# 適航指令發布單

民航局 AD 編號 AD number	CAA-2023-06-007	發布日期 Date issued	2023/6/28
適用之航空產品 Applied to (models, serial numbers or part numbers, as applicable)	Boeing Model 747 - 8F and 747 - 8 series airplanes. and Model 777 - 200, - 200LR, - 300, - 300ER, and 777F series airplanes.		
主旨摘要 Subject	This AD requires revising the limitations section of the existing AFM to incorporate limitations prohibiting dispatching or releasing to airports, and approaches or landings on runways, due to the presence of 5G C-Band interference.		
民航局 CAA <input type="checkbox"/> 本國產品 Native product <input type="checkbox"/> 其他個案 Other	設計國民航主管機構 Original Authority <div style="display: flex; justify-content: space-between;"> <div style="width: 48%;"> <input checked="" type="checkbox"/> FAA  <input type="checkbox"/> EASA  <input type="checkbox"/> Brazil  <input type="checkbox"/> Transport Canada Civil Aviation  <input type="checkbox"/> DGAC             </div> <div style="width: 48%;"> <input type="checkbox"/> Germany LBA  <input type="checkbox"/> CAA-NL  <input type="checkbox"/> UK CAA  <input type="checkbox"/> Japan CAB  <input type="checkbox"/> CAA of Israel  <input type="checkbox"/> Other _____             </di

Figure 1 to paragraph (g)(2)(i)— *Fundamental Effective Isotropic PSD at Outside Interface of Aircraft Antenna*

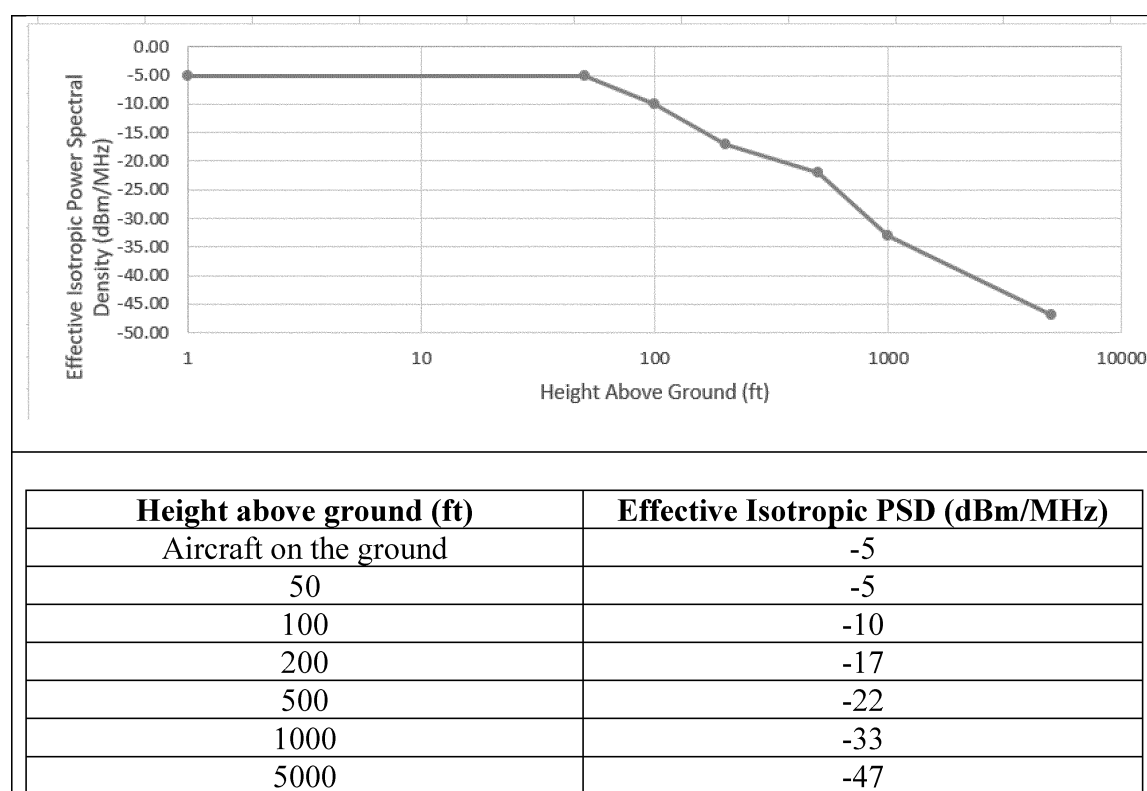
(i) Tolerance to radio altimeter interference, for the fundamental emissions (3.7–3.98 GHz), at or above the power spectral density (PSD) curve threshold specified in figure 1 to paragraph (g)(2)(i) of this AD.

Figure 2 to paragraph (g)(2)(ii)— *Spurious Effective Isotropic PSD at Outside Interface of Aircraft Antenna*

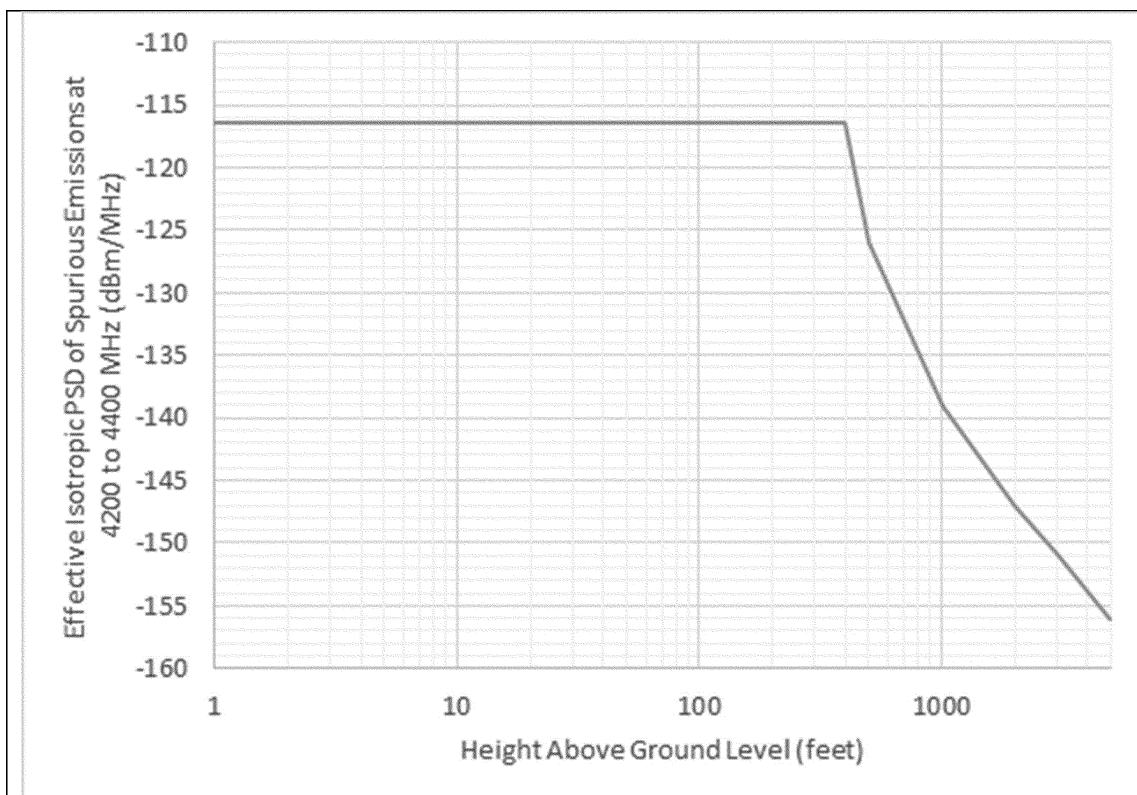
(ii) Tolerance to radio altimeter interference, for the spurious emissions (3.7–3.98 GHz), at or above the PSD curve threshold specified in figure 2 to paragraph (g)(2)(ii) of this AD.

<u>Aircraft Altitude (ft AGL)</u>	<u>Effective Isotropic PSD (dBm/MHz)</u>
1	-116.50
400	-116.50
500	-126.00
1000	-139.00
2000	-147.00
3000	-151.00
5000	-156.00
